WASTEWATER IMPROVEMENTS
WINDRUSH TO CARLTON PARKE
MADISON COUNTY, MISSISSIPPI

PWP-05035

DRAWING TITLE
PLAN & PROFILE

CONTRACT SHEET **S-1**

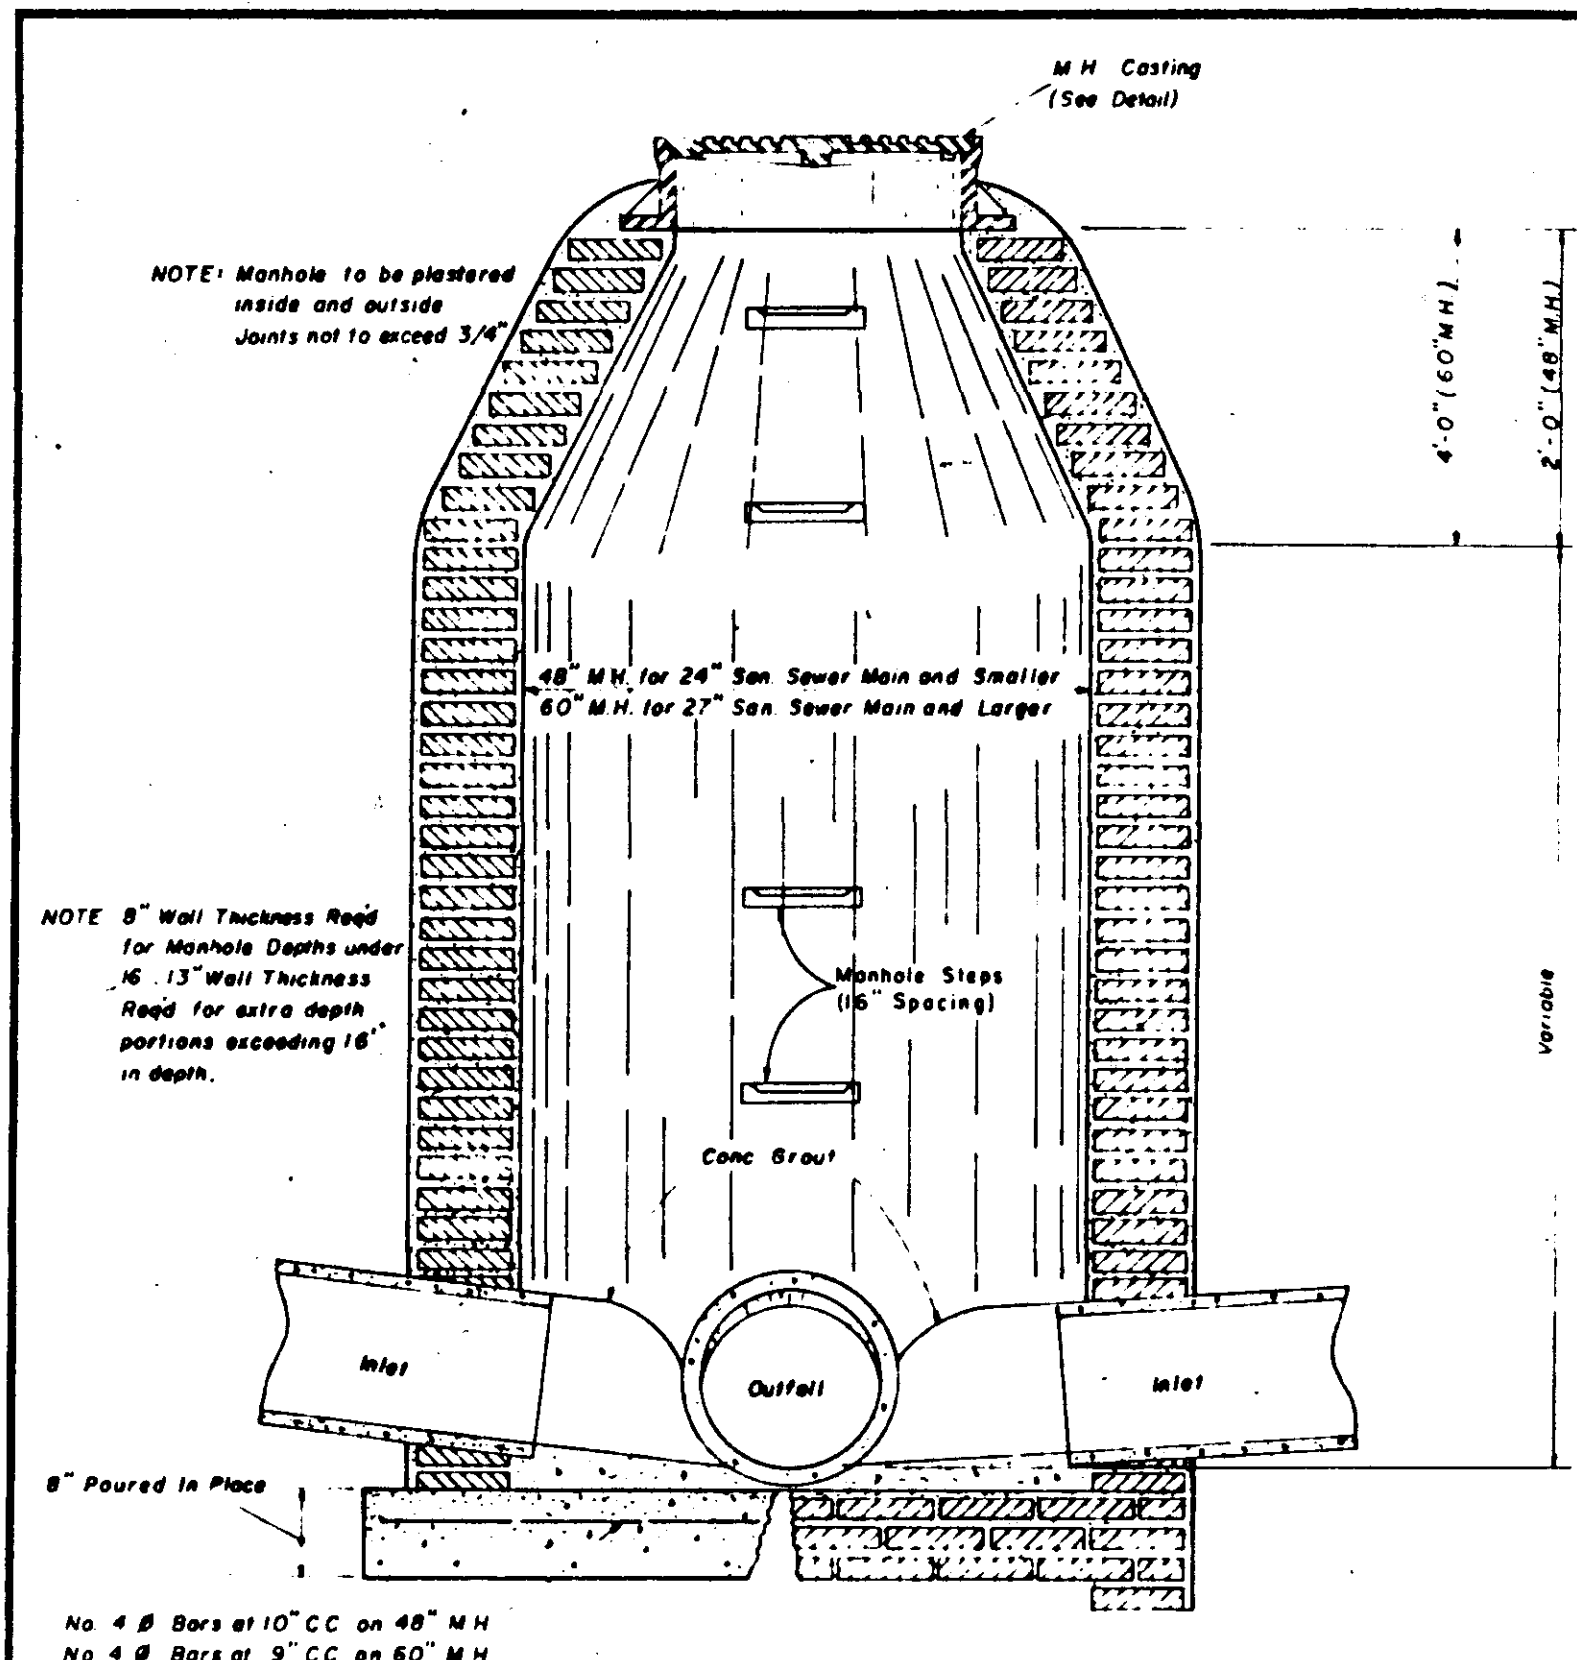
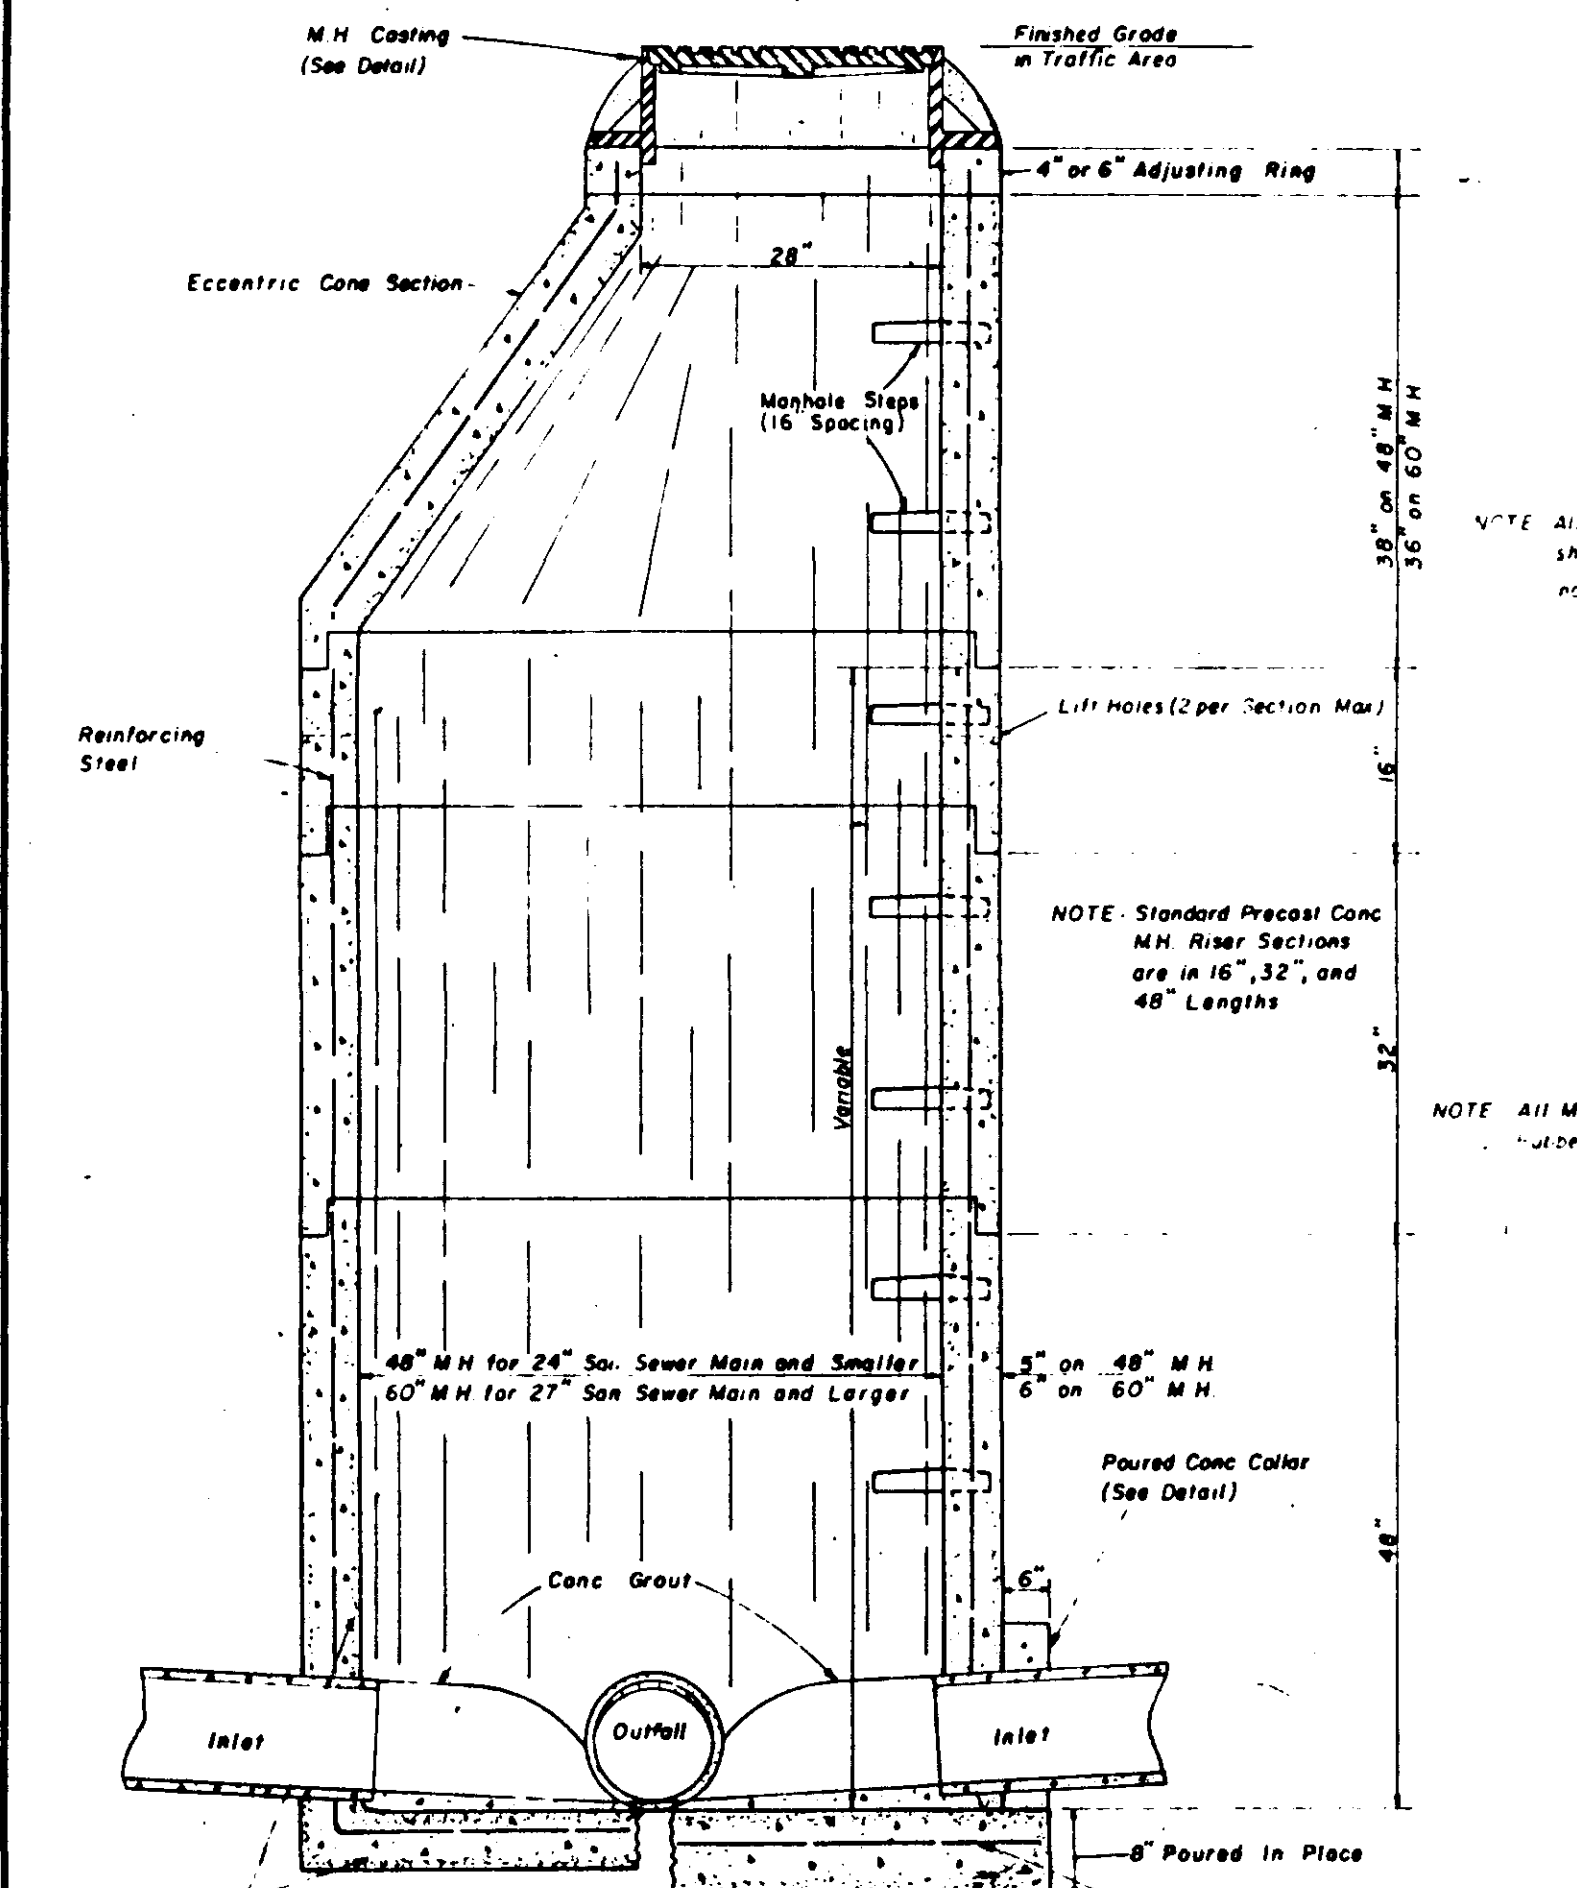
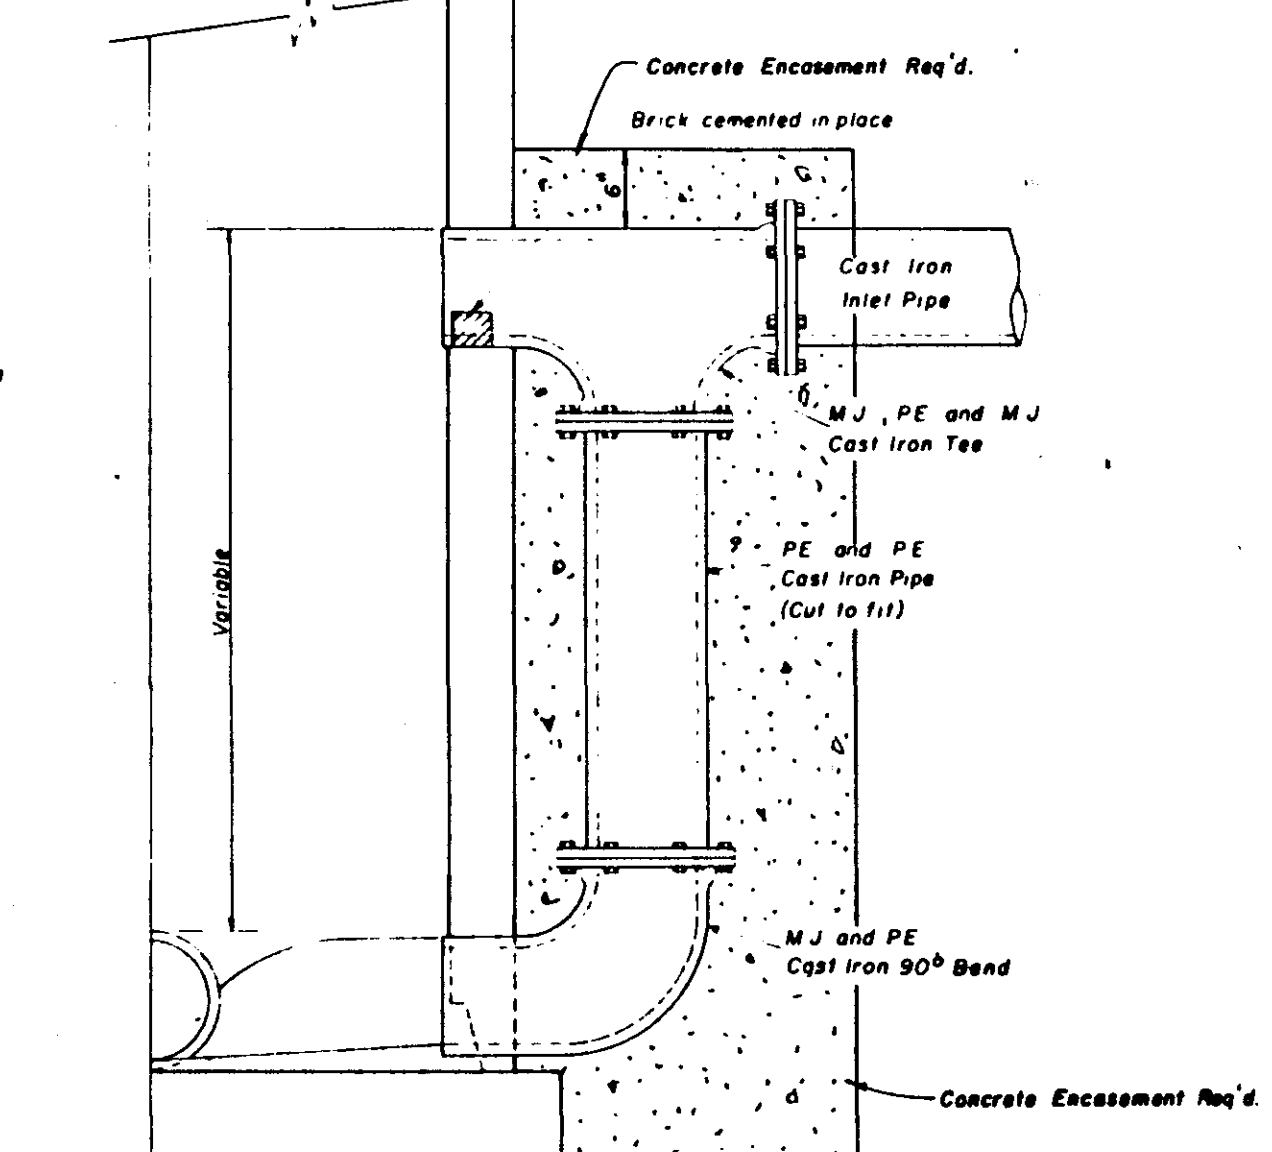
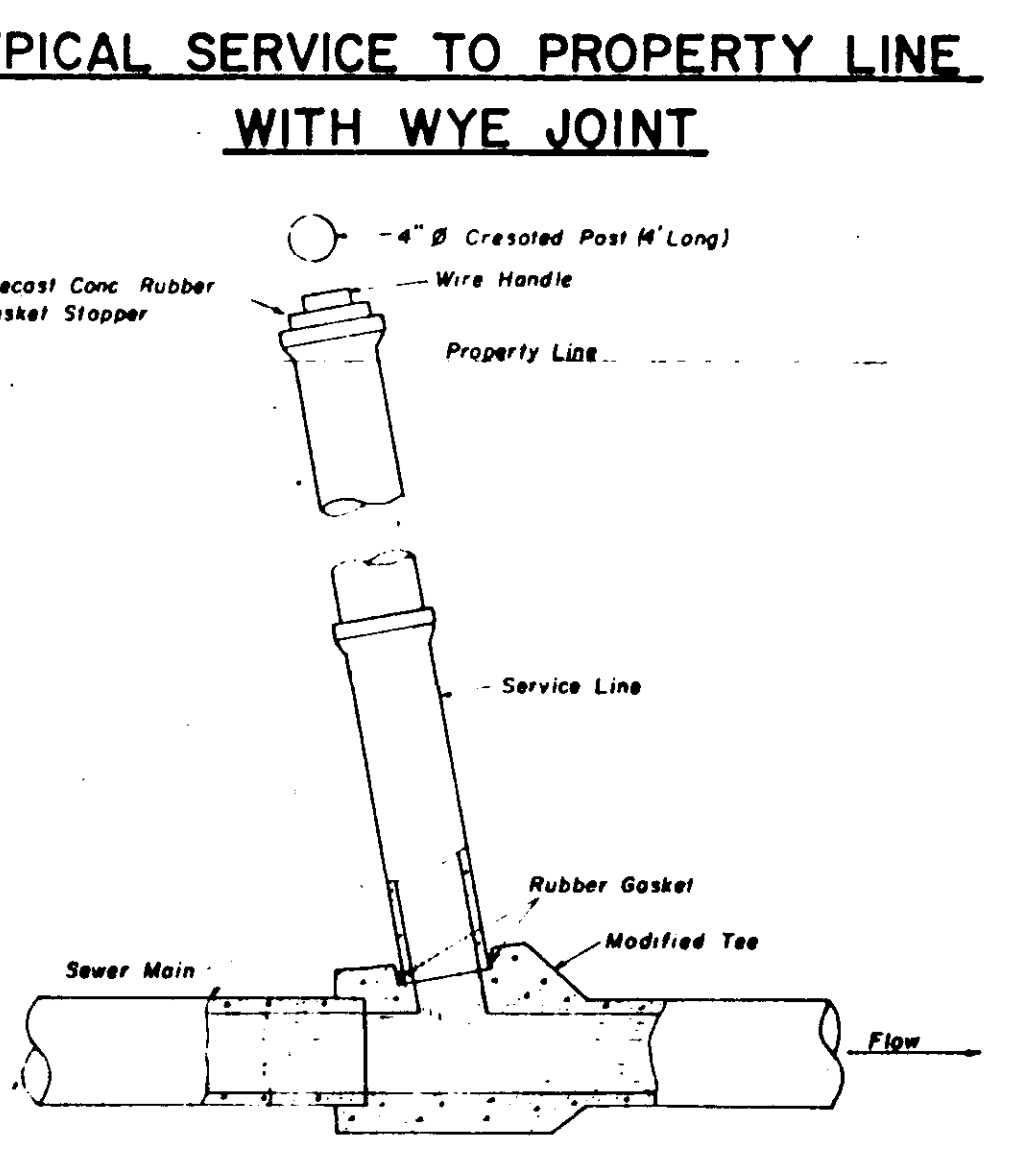
*No City Standards
Sheet*
